PRODUCT CHANGE NOTIFICATION

Bourns® Model SRN8040 Series Semi-shielded Power Inductors

Change to Inductor Core Design and Wire Diameter

Existing Inductor Core Design

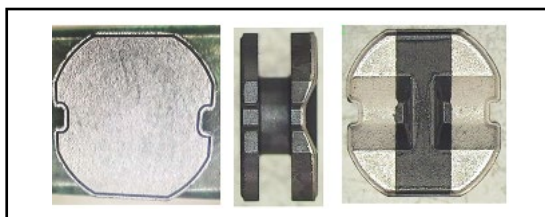
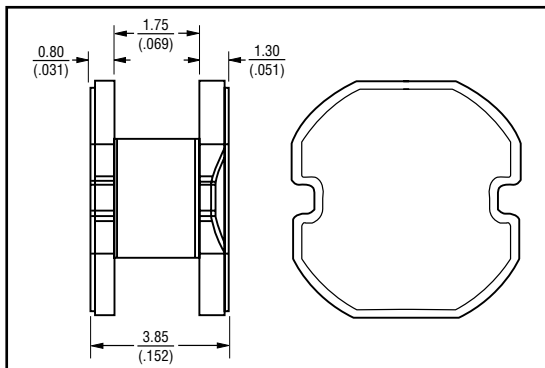
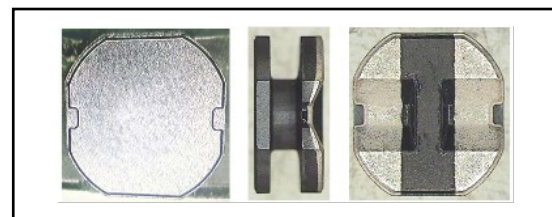
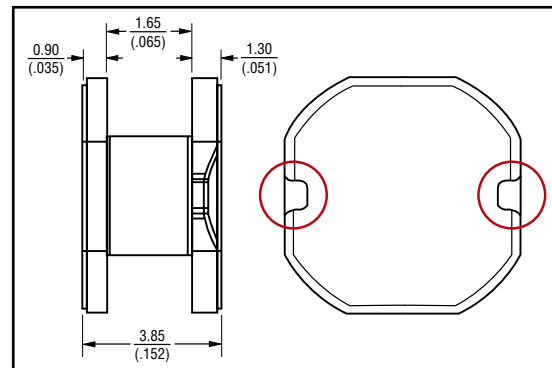
Riverside, California – August 13, 2021 – Effective February 12, 2022, Bourns will change the inductor core design of the [Model SRN8040 Series Semi-shielded Power Inductors](#). The modified inductor core will be comprised of a thicker top flange, removal of wire channels on the top flange and a reduced winding length. These modifications will strengthen the core structure and reduce the risk of a core crack.

The form of the inductor will be changed. The fit and function remain the same. The quality and reliability of the component should be improved as a result of the design change.
